**REMARKS / ARGUMENTS**

Appl. No. 10/024,987

Amtd. dated December 30, 2003

Reply to Office Action of September 2, 2003

Appl. No 10/024,987  
Arndt. Dated Dec. 30, 2003  
Reply to Office action of Sep. 2, 2003  
Annotated Sheet Showing Changes

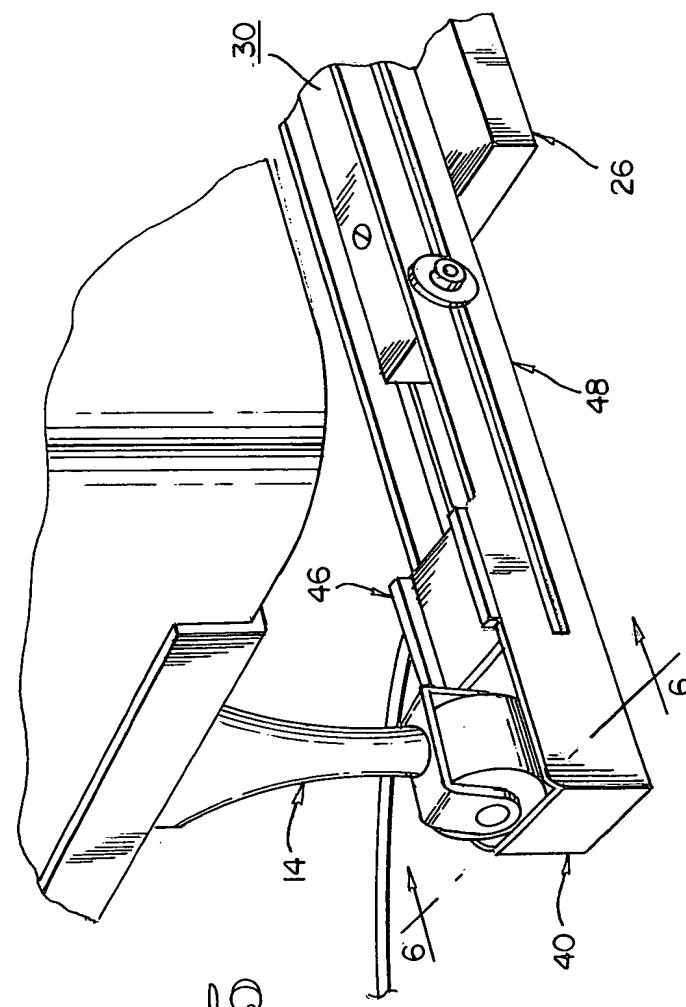
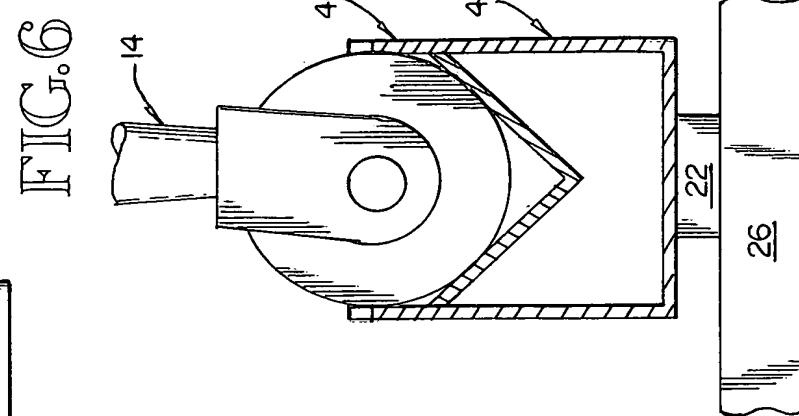
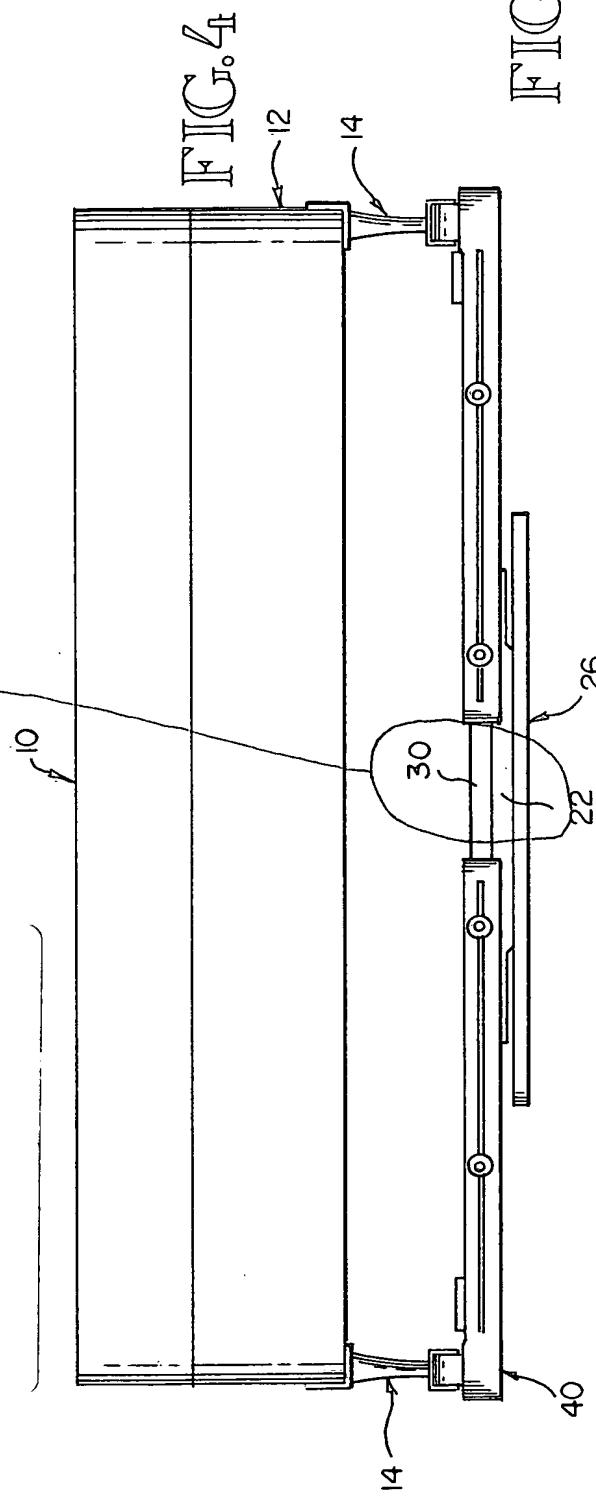
Claims 1-7 were rejected in the office action for failing to describe the invention such that one of reasonable skill in the art could practice the invention. The office action noted that “[w]ith the solid support bar 30 laying across the entire length of the double-ended load cell 22, it is unclear how the load cell actually measures weight.” The office action went on to note that the end portions of load cells are generally free to flex independently of the fixed center of the load cells, and that if the solid beam were laying across the top of the load cell, and actually making physical contact with the top, some of the weight of a person and bed would be transmitted through the fixed center of the load cell.

Applicant respectfully responds that it may appear that the entire load on a scale is suspended across the entire length of the double-ended load cell. However, it is not. The support bar is constructed in such a way that there is contact only at the end portions of the load cell. This allows for unobstructed flexing at the ends of the load cell from the fixed center portion of the cell such that the strain gages can give an accurate measure of weight.

Addition of line to more clearly show the relationship between the Sulfur Bar 30 (number added) and the load cell 22.
